5. Birch Forest No. 3; KPB File 2022-151R1 Edge Survey & DesignPoppin Family Revocable Community Property Trust Location: Erlwein Road, Erlwein Circle, Smith Road & Shishmaref Drive Sterling Area

ITEM #5 - PRELIMINARY PLAT Birch Forest No. 3 Phase 1

KPB File No.	2022-151R1	
Plat Committee Meeting:	April 22, 2024	
Applicant / Owner:	Poppin Family Revocable Community Property Trust of Soldotna, Alaska	
Surveyor:	, , , , , , , , , , , , , , , , , , ,	
General Location:

STAFF REPORT

BIRCH FOREST No. 3 PHASE 1

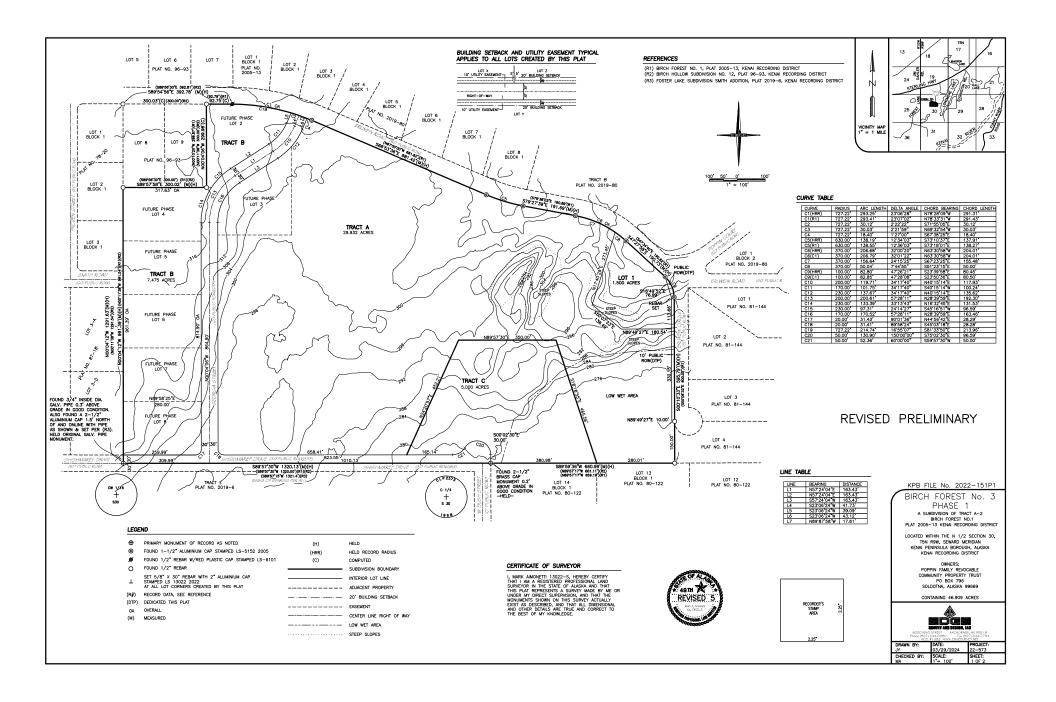
Correct KPB File No to 2022-151R1

Show the setting of a monument at the southwest corner of the dedication of Erlwein Circle.

Show setting of monuments along Georgia Street and Shishmaref and Tract C and Lot 1 Tract C linework is too dark, match interior lines of lot 1.

Lot 12 to southeast needs Blk 2 added

<u>Staff Discussion:</u> A through dedication of Smith Road should be provided to connect to the new north-south dedication proposed. This would provide a complete block for the area west of this subdivision and provide for projection and extension of the existing dedication.

Denial of the exception will require a through dedication of Smith Street to connect to the new dedication.

Staff Discussion: The block to the east of the new dedication along Erlwein Rd will exceed allowable limits and is

not closed due to the cul-de-sac to the east.

4. There does not appear to be a remainder after future lots are created.
